I-5507 - Interstate 485 improvements from I-77 to US 74 (Independence Blvd)

Subject: **Request for Modification for Section 404 Regional General Permit No. 201902350 and Section 401 Water Quality Certification** for the Interstate 485 (I-485) improvements from I-77 to US 74 (Independence Boulevard), Mecklenburg County, Division 10, TIP I-5507. Debit \$570.00 from WBS 43609.3.2.

Revised July 2023
**PERMIT DRAWING
SHEET 18 OF 115**

PERMIT DRAWING
SHEET 75 OF 115

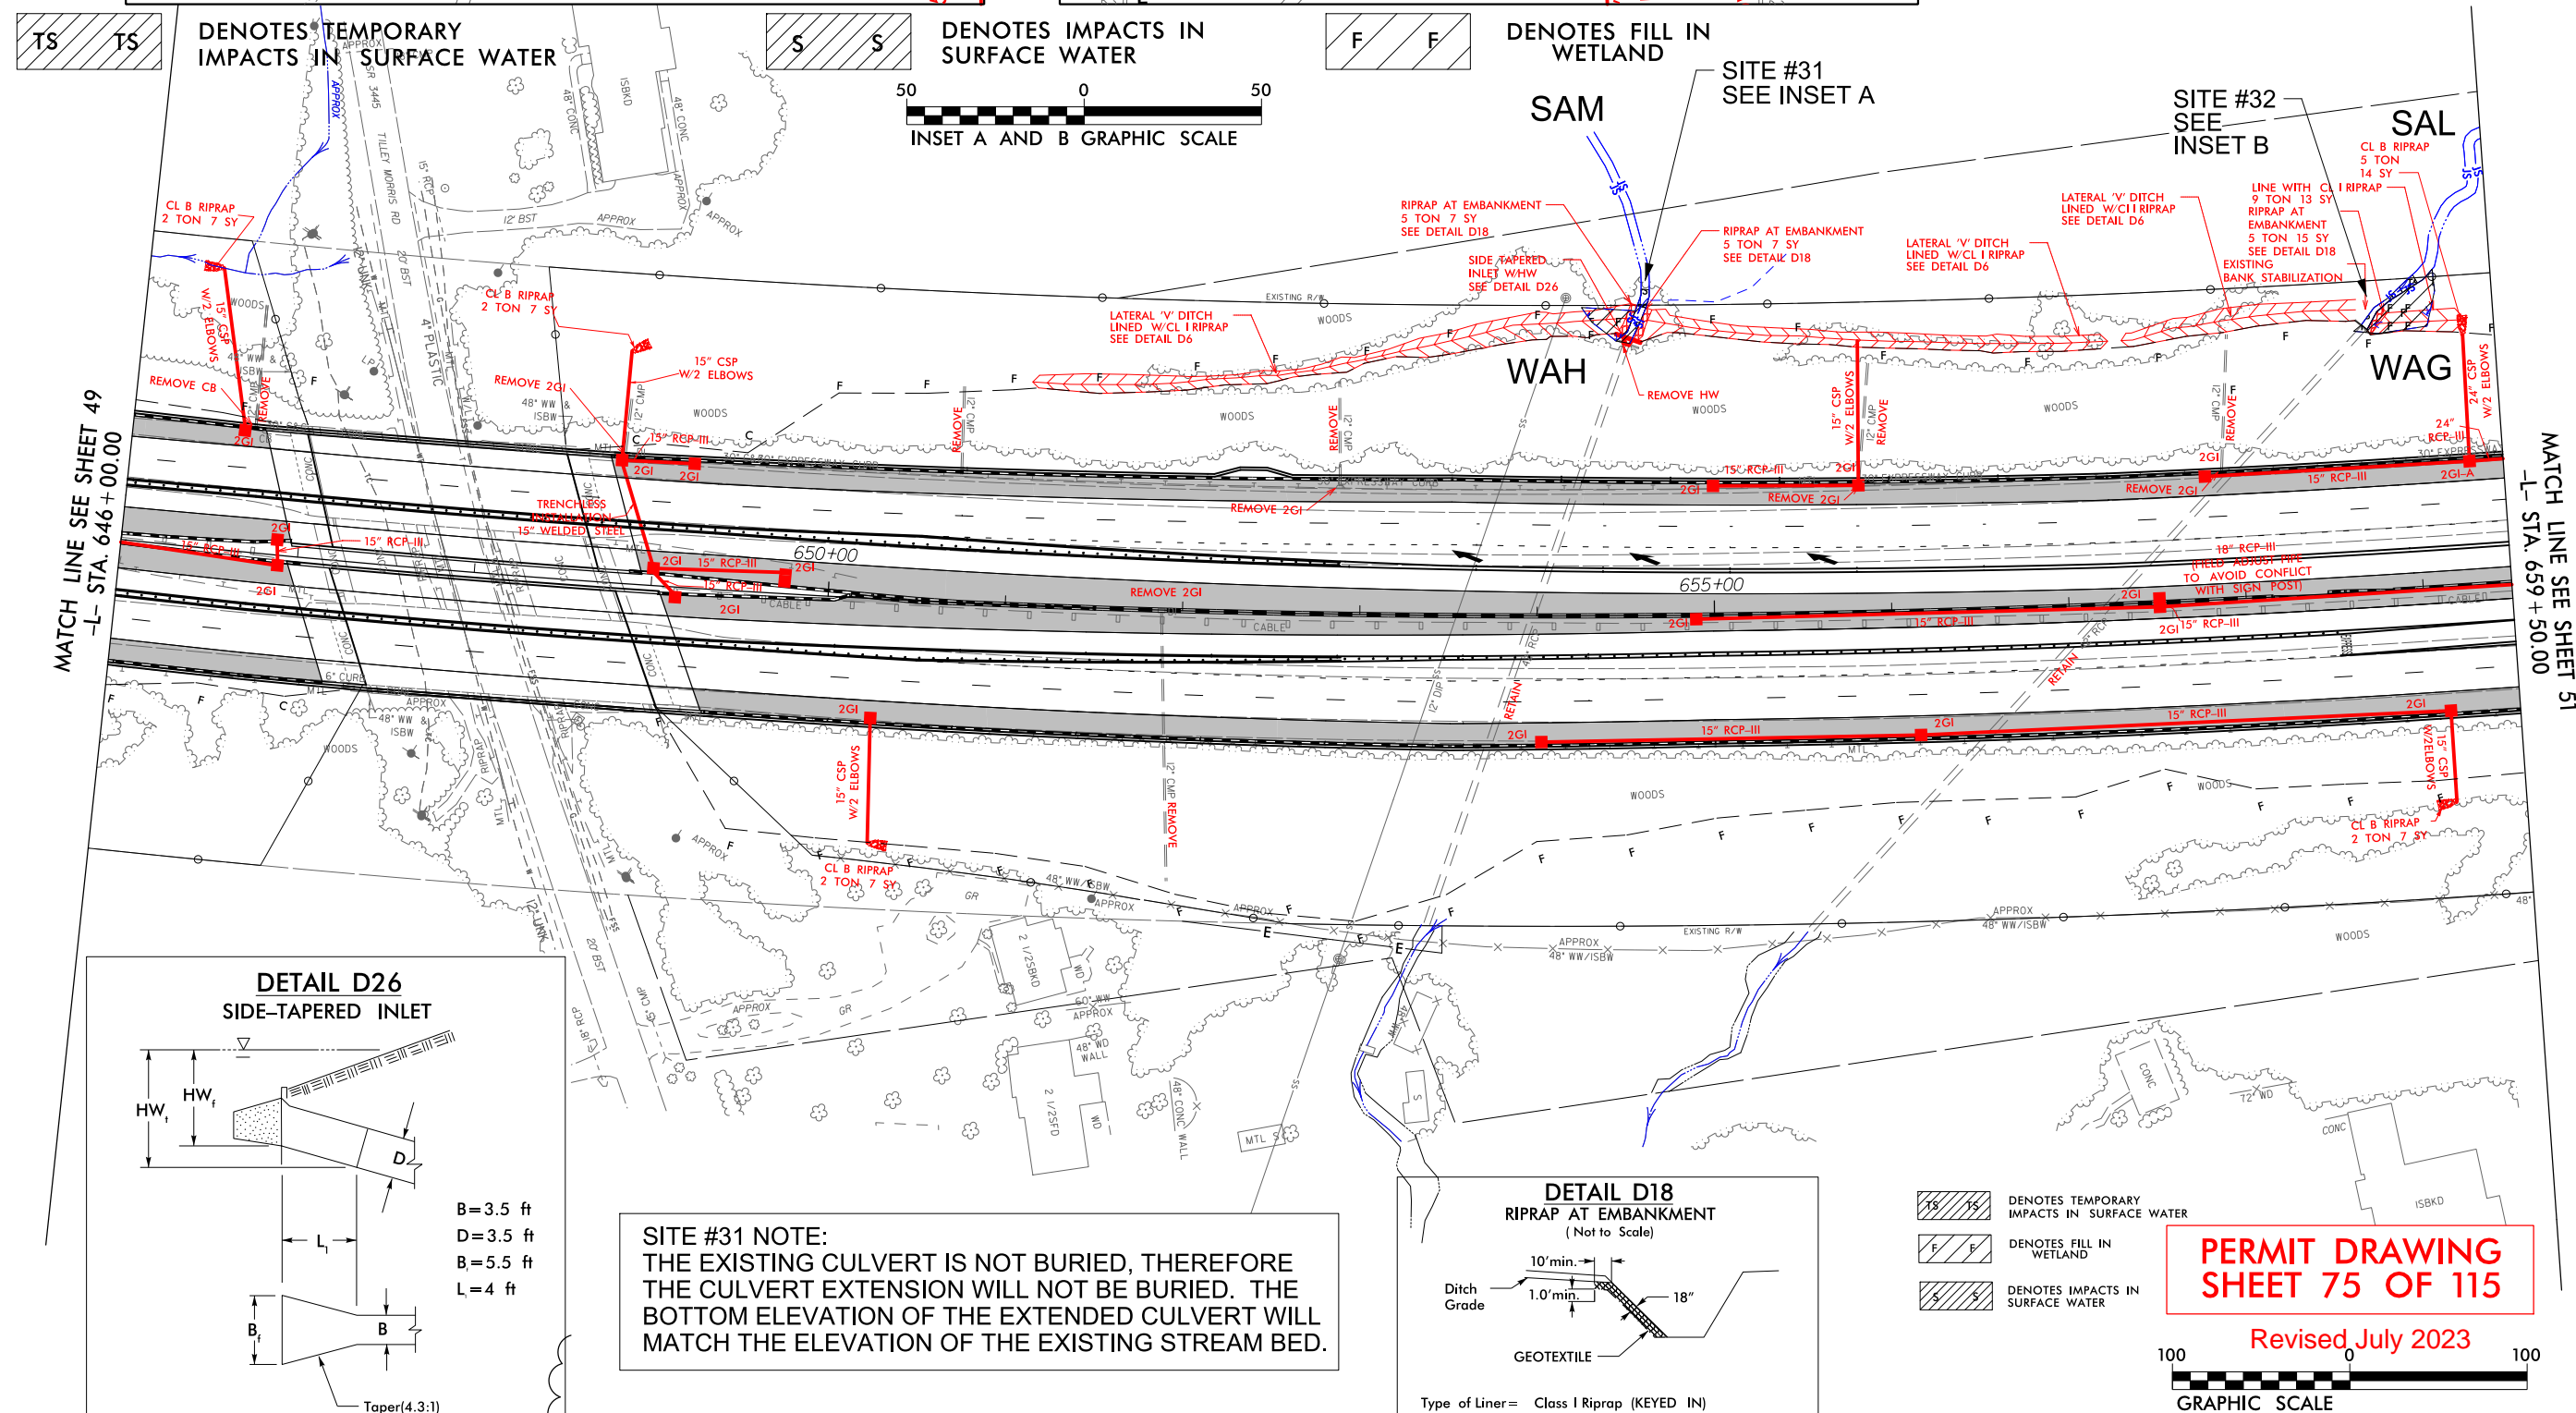
The original approved impacts at Site 31 included 3 linear feet of permanent stream impacts associated with the extension of a 42" RCP, 20 linear feet of stream bank stabilization, 10 linear feet of temporary stream impacts, and < 0.01 acre of permanent wetland fill impacts associated with a lateral ditch tie-in. The drainage design has been revised at this site to widen and extend the lateral ditch, resulting in an additional 1 linear foot of permanent stream impact from the culvert extension and 1 linear foot less of stream bank stabilization. The revised impacts at Site 31 include 4 linear feet of permanent stream impacts associated with RCP extension, 19 linear feet of stream bank stabilization, 10 linear feet of temporary stream impacts, and < 0.01 acre of permanent wetland fill.

**PERMIT DRAWING
SHEET 76 OF 115**

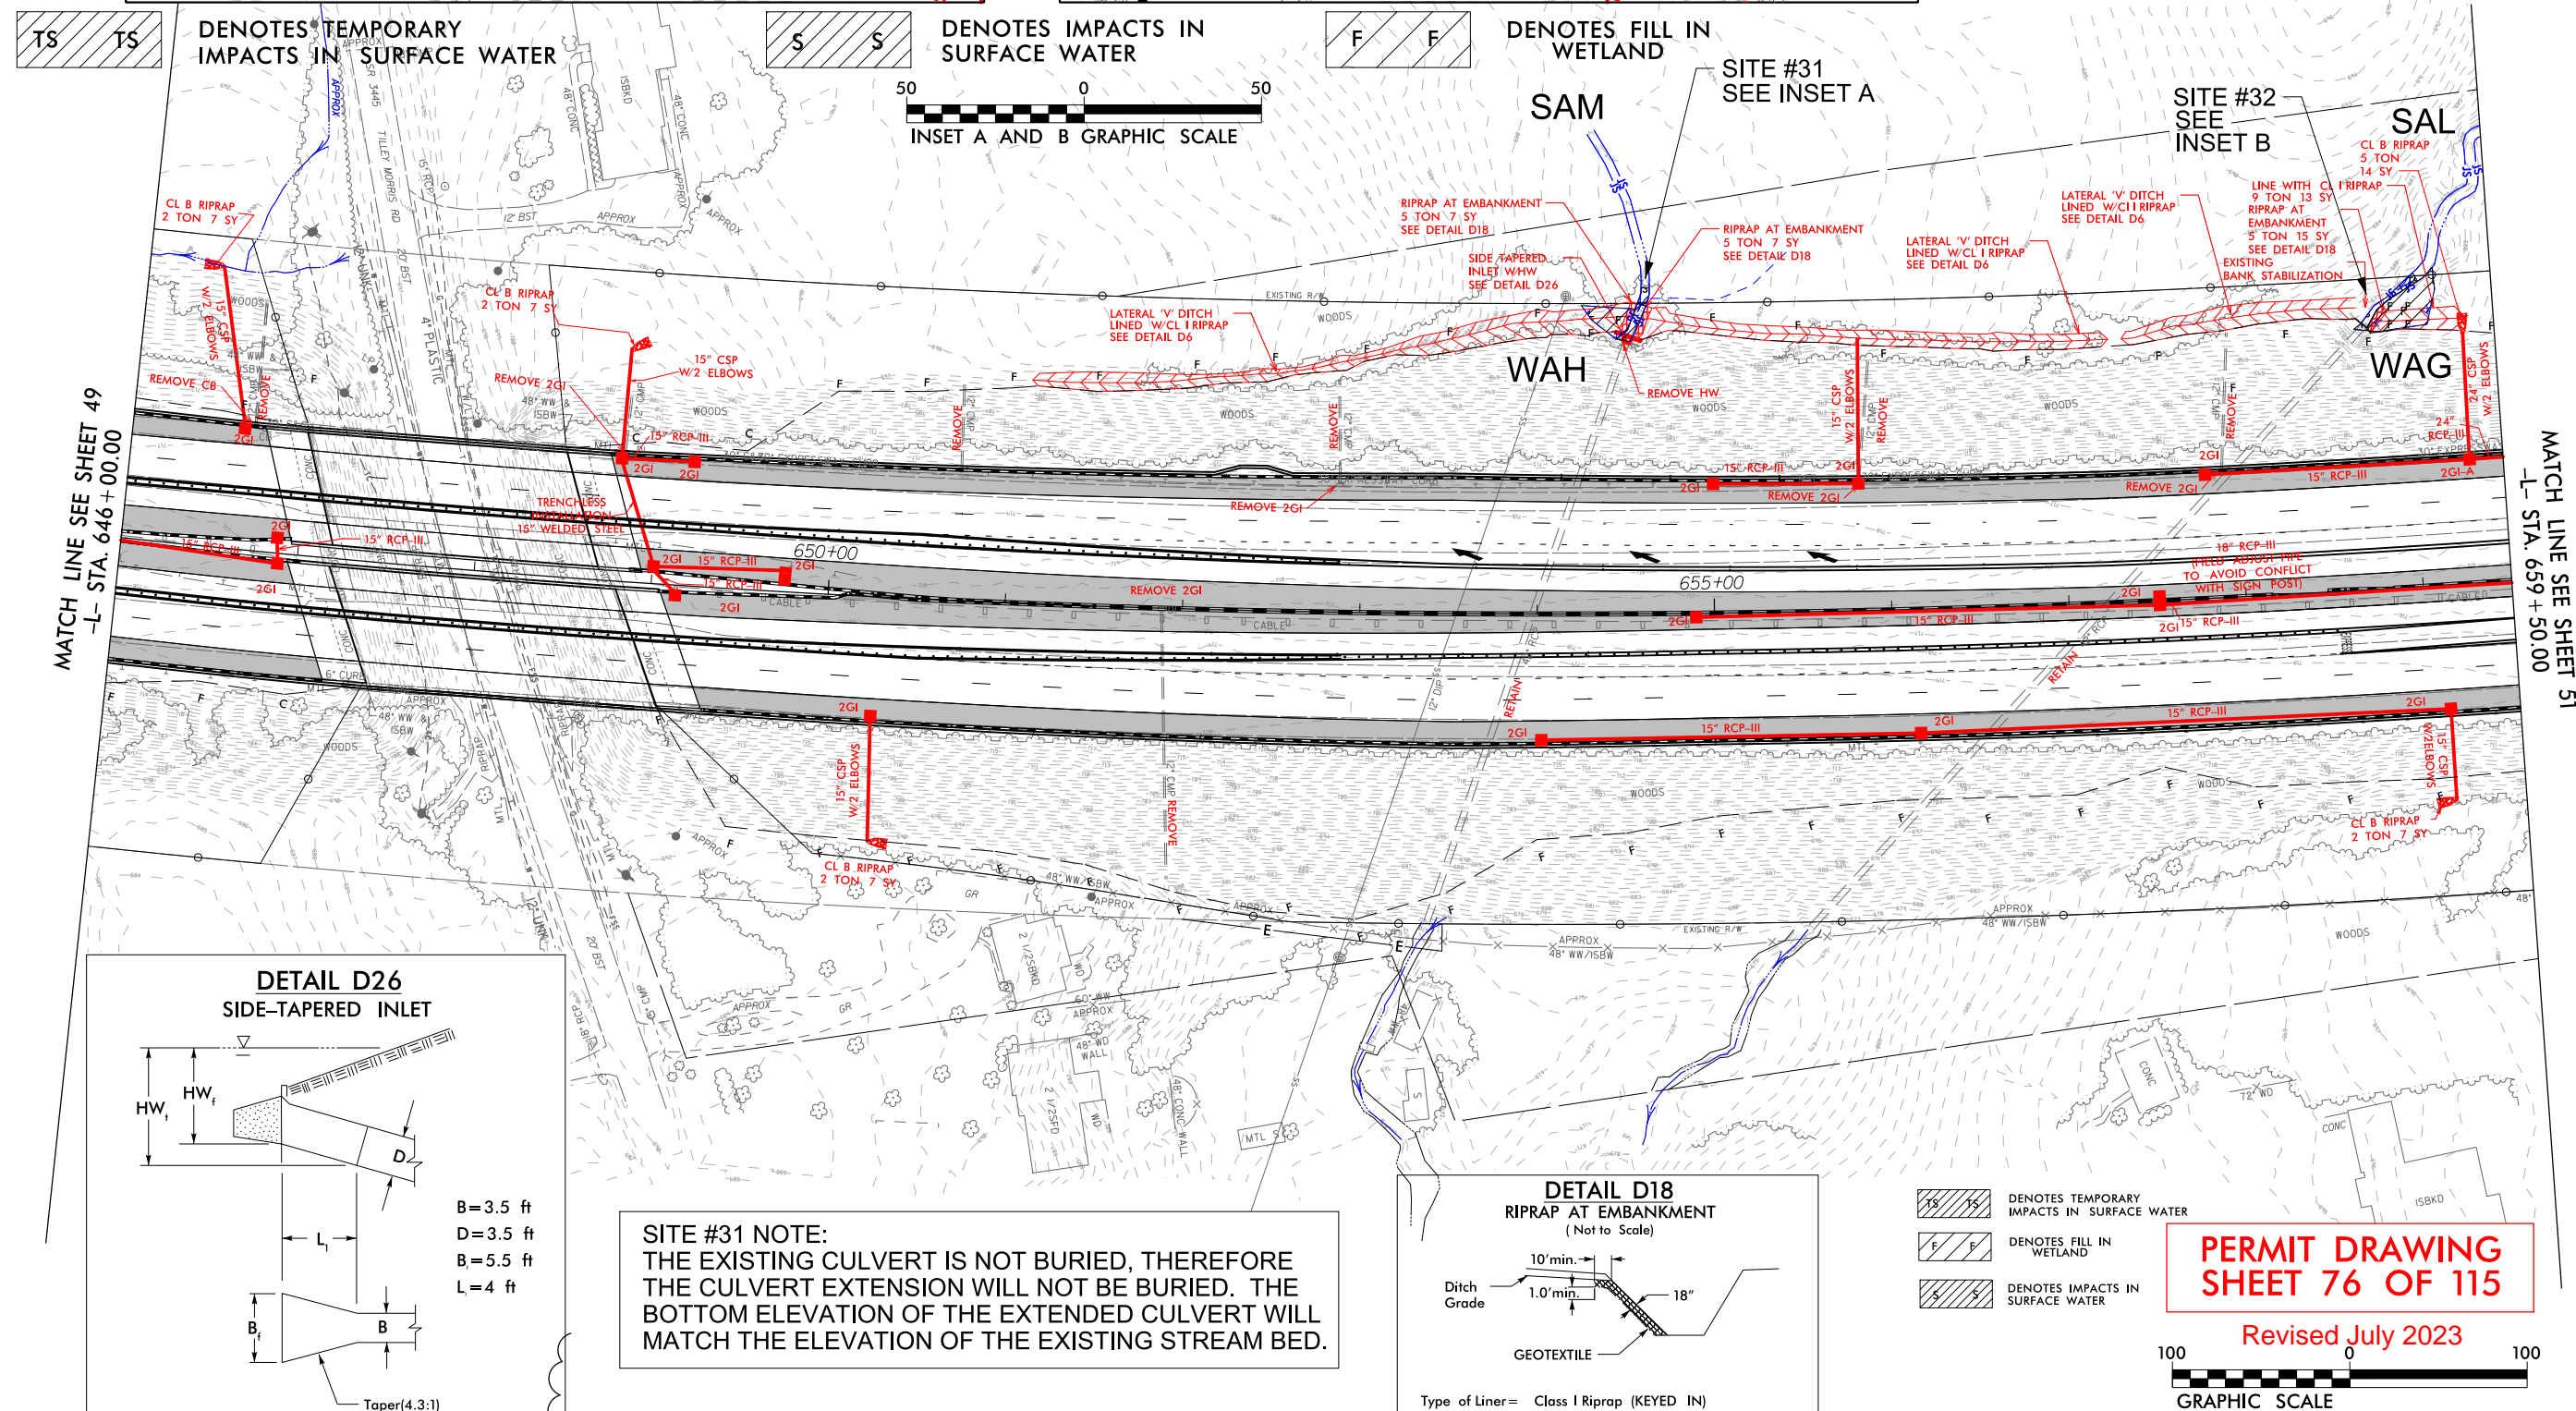
The original approved impacts at Site 32 included 6 linear feet of stream bank stabilization, 20 linear feet of temporary stream impacts, and 0.02 acre of permanent wetland fill impacts associated with roadway fill and a storm water outfall tie-in. The drainage design has been revised at this site to add lateral ditches. The lateral ditch from the west will discharge prior to an existing riprap bank and will not result in impacts to the right bank. The lateral ditch from the east will drain to a proposed riprap bank, resulting in 15 linear feet of stream bank stabilization impact, 24 linear feet of temporary stream impacts, and 0.02 acre of permanent wetland fill impacts.

PERMIT DRAWING
SHEET 84 OF 115

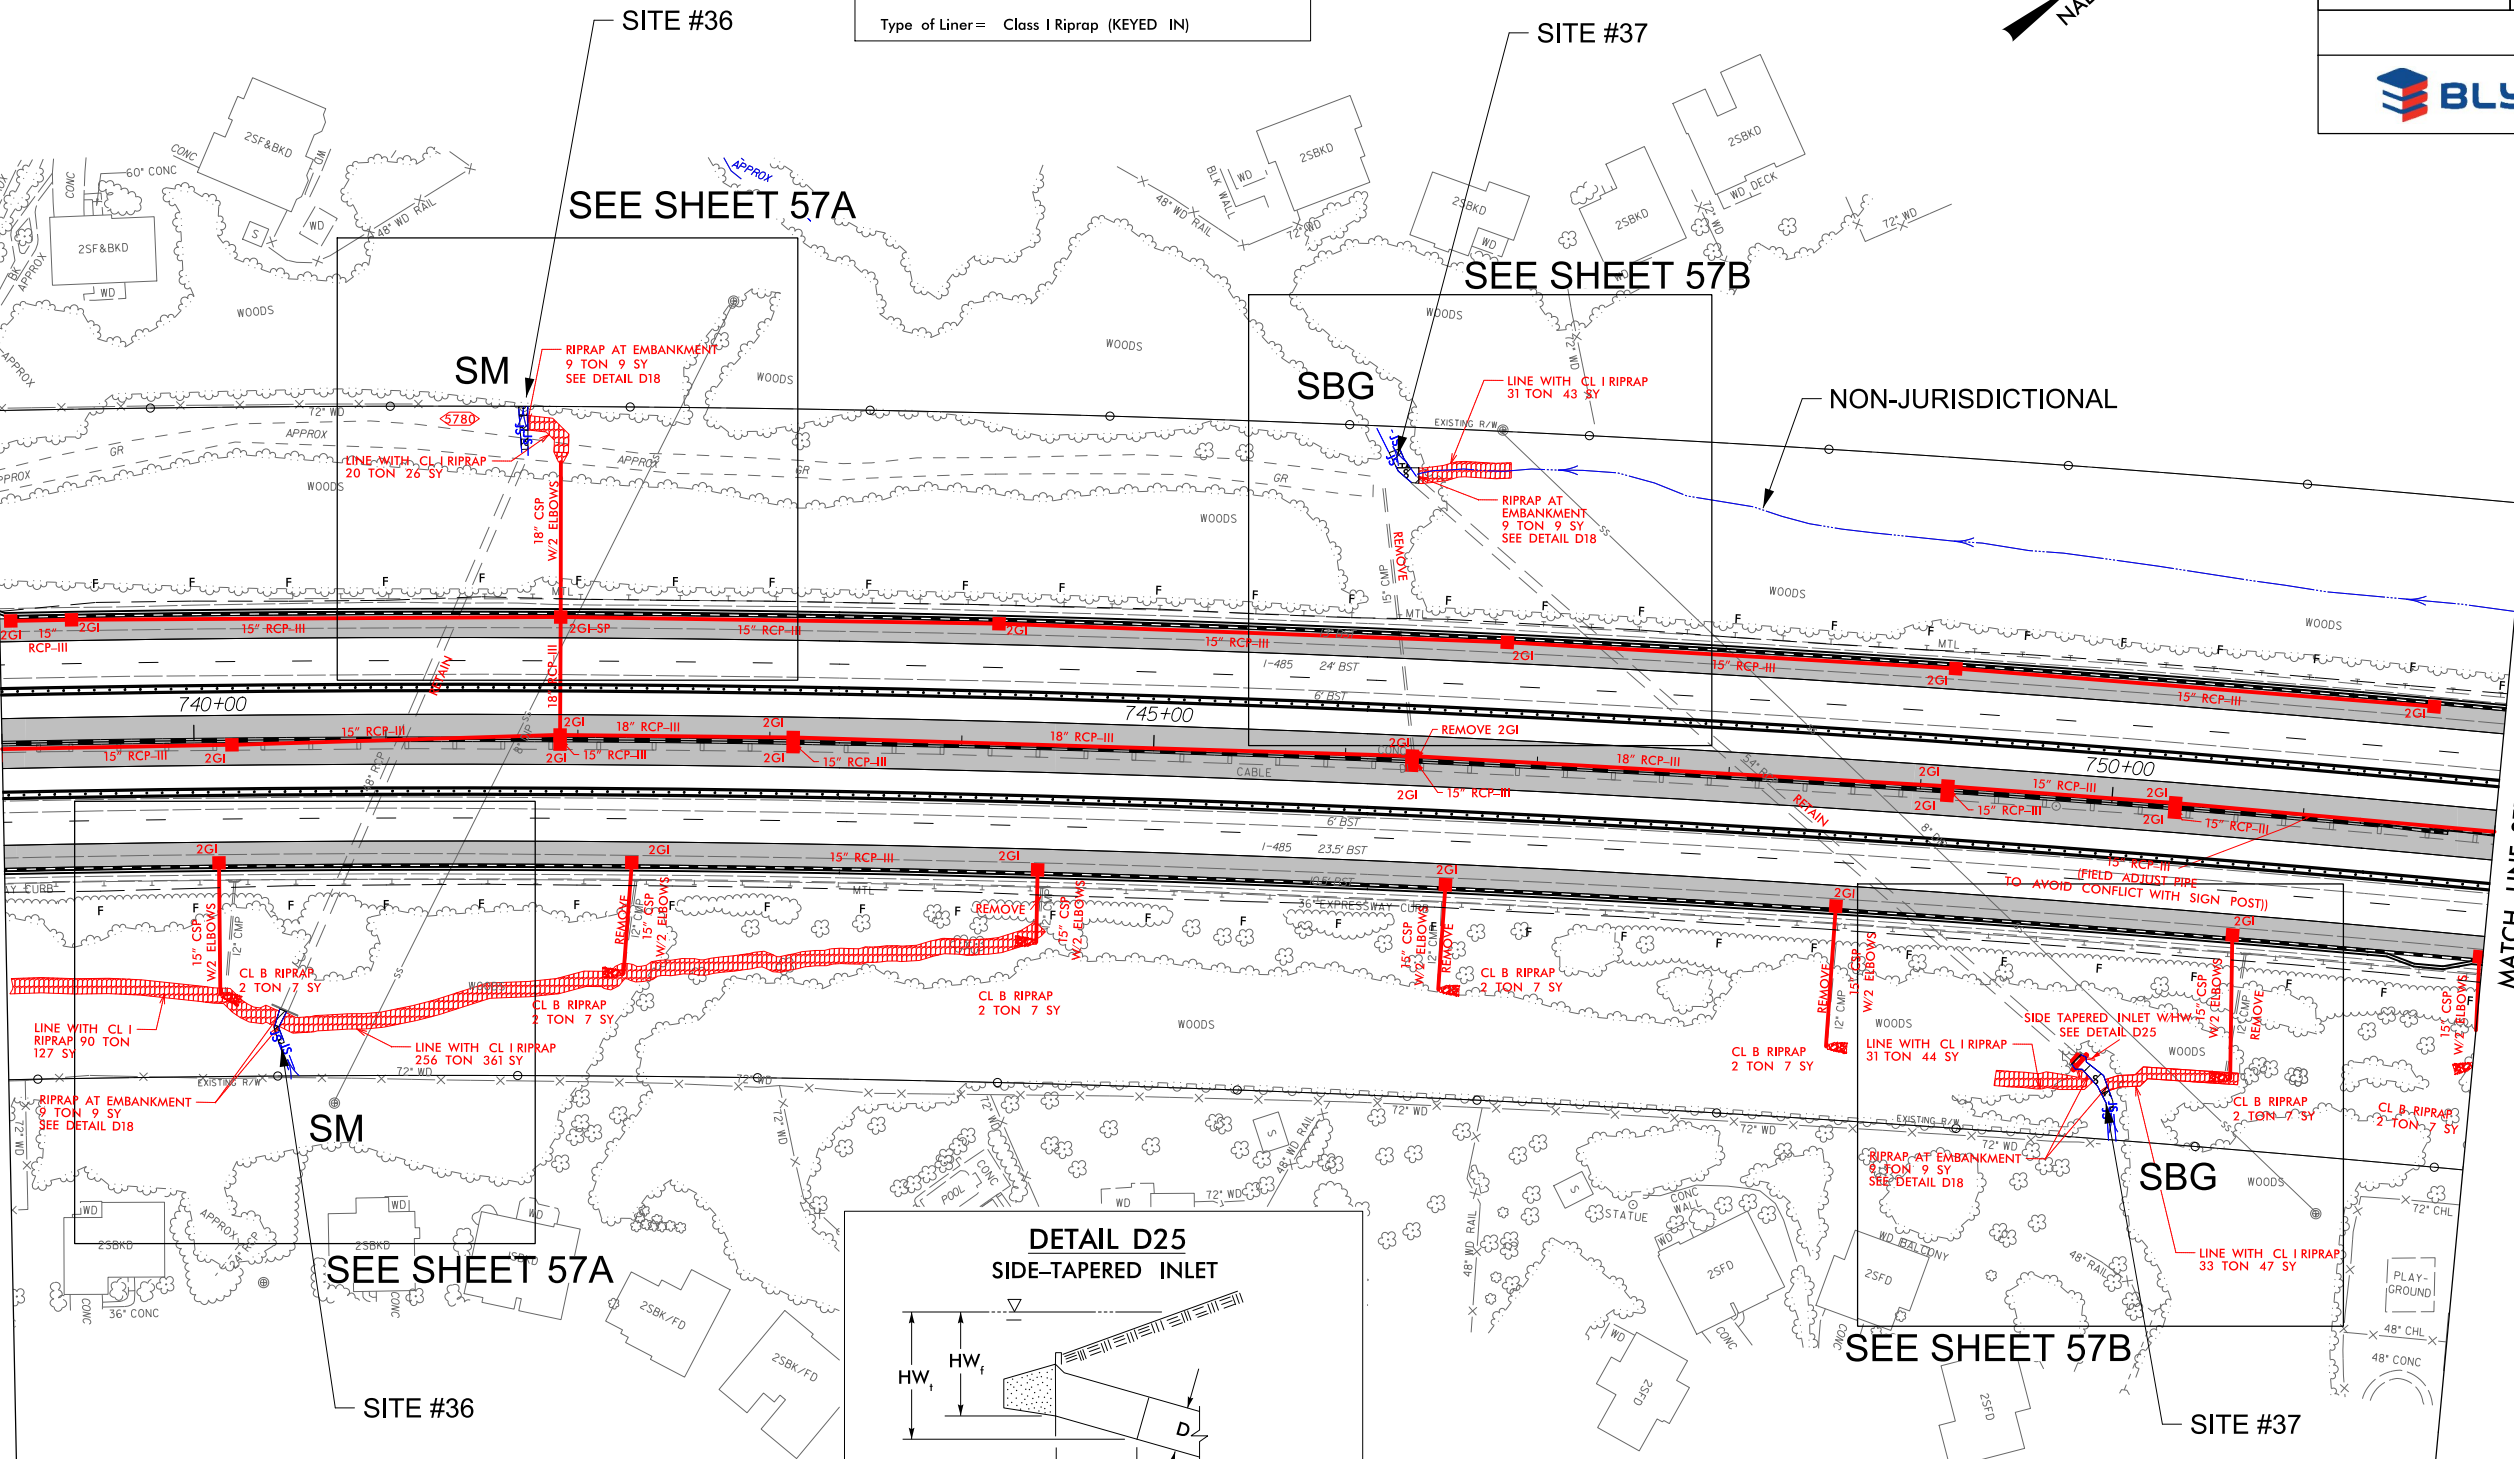
The original approved impacts at Site 37 included 35 linear feet of stream bank stabilization and 20 linear feet of temporary stream impacts associated with lateral ditch outfall tie-ins. The design has been revised near Station 749+80 to include a 4 ft extension to the existing 54" RCP at this site. The revised impacts at Site 37 include 4 linear feet of permanent stream impacts associated with the RCP extension, 31 linear feet of stream bank stabilization, and 20 linear feet of temporary stream impacts.
